**ONONDAGA LAKE BOTTOM  
PHASE I – SEDIMENT CONSOLIDATION  
AREA CONSTRUCTION  
CONSTRUCTION QUALITY ASSURANCE (COA)  
FINAL REPORT – Volume I  
ONONDAGA COUNTY  
TOWN OF CAMILLUS, NEW YORK**

Project Number GJ4706B

May 2012 (Revision 0)  
August 2012 (Revision 3)

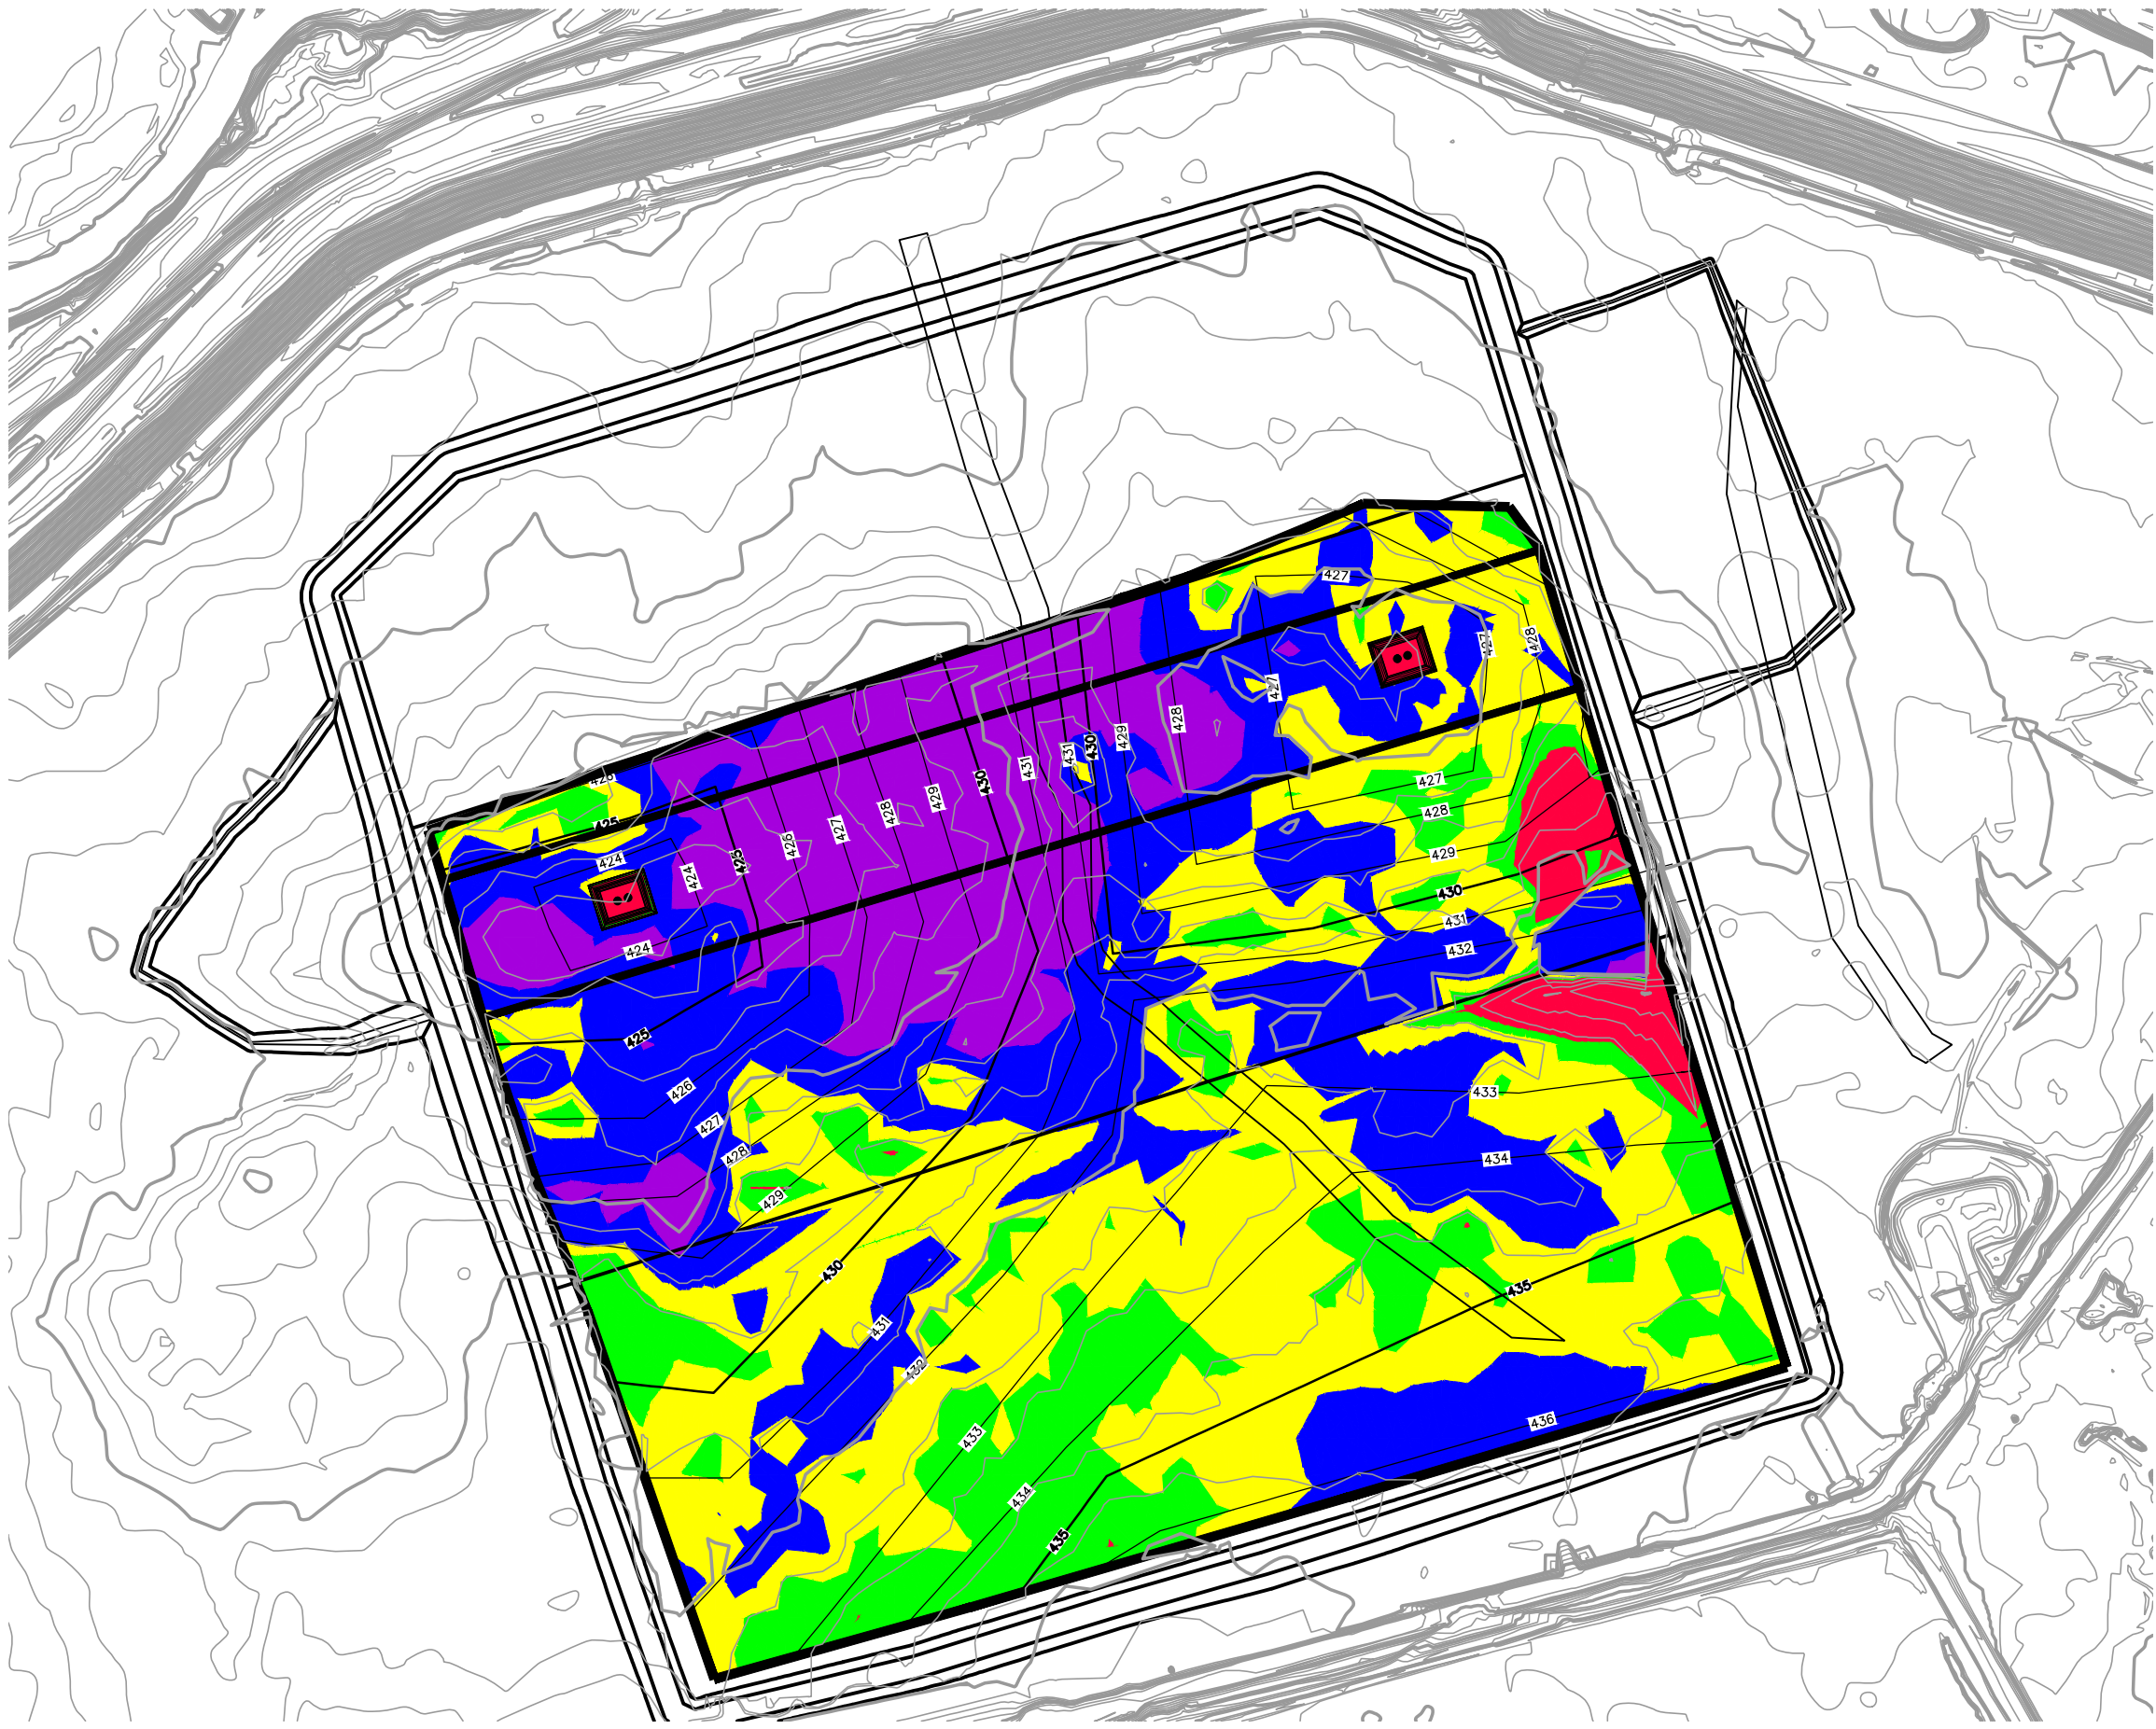
### QUESTION:

Once approved we will prepare a revised top of clay layer within 2 to 3 working days of approval of the revised existing surface.

NOTE: Revised clay grades have been received from Geosyntec and the berms are to be built to the height (i.e., vertical distance between the ground and the top of the dike) shown in the design (elevation can be lower than design elevation). per Dave Steele (24 Jun 11)

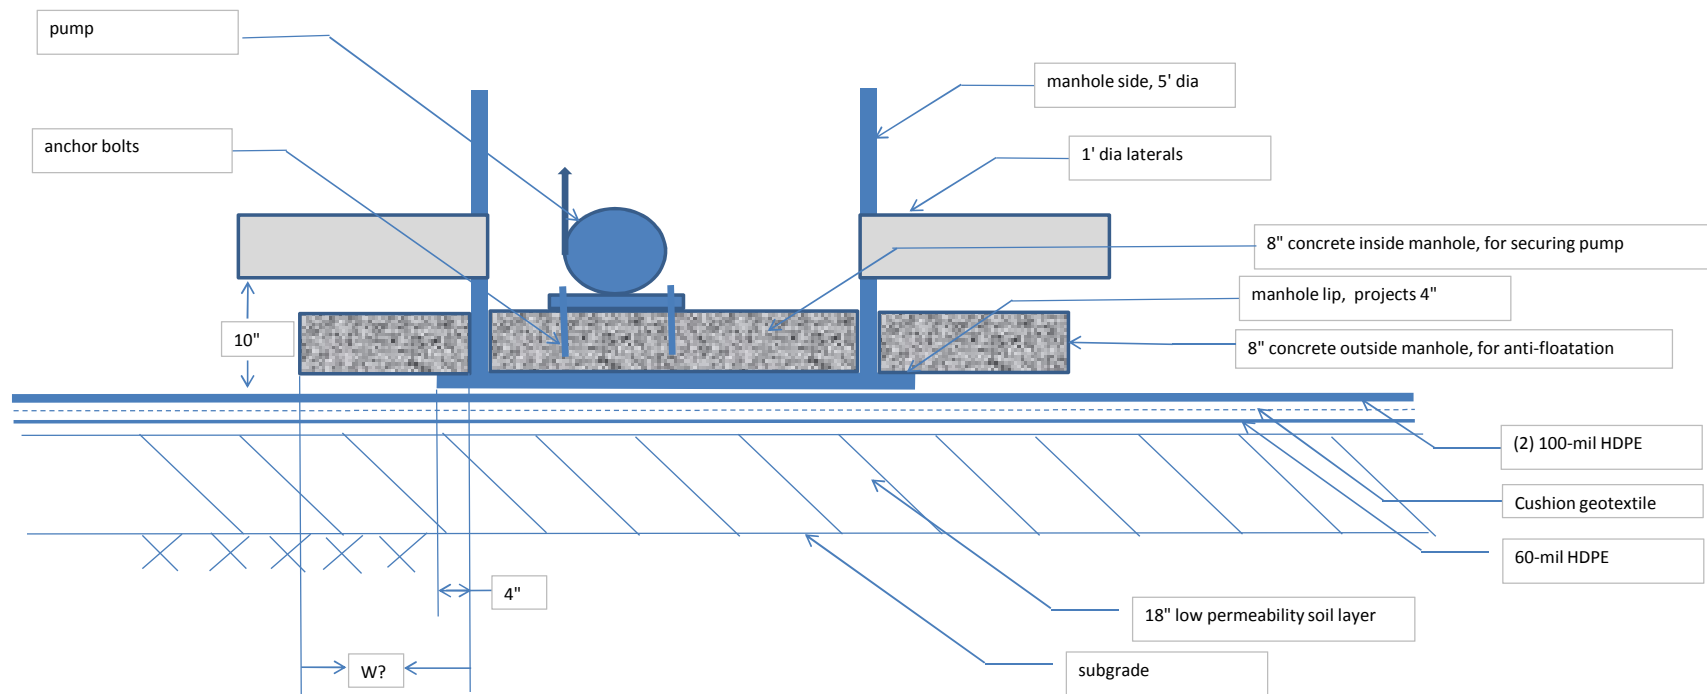
What is the "pump off" water level for the proposed pumps? What is the proposed method for accessing the bolted pumps for repair/maintenance? The design only covered permanent pumps after closure.

The concrete pad portion outside the riser should rest on the (2) 100-mil HDPE geomembrane sheets, with no gap in between. Concrete pad should also be constructed in a manner to not lead to separation of the pad and the riser. The proposed lip thickness of 4 inches should be conformed with the manufacturer/installer as adequate to provide the transfer of the concrete to the riser without leading to separation during uplift.

The 12 inch diameter lateral pipes should be placed directly on the concrete pad and should be provided with firm bedding beyond the concrete pad. The low point of these lateral pipes should be the riser connection and the straight run on the concrete pad.

Permanent pumps were proposed to be submersible and lifted to the surface for maintenance.
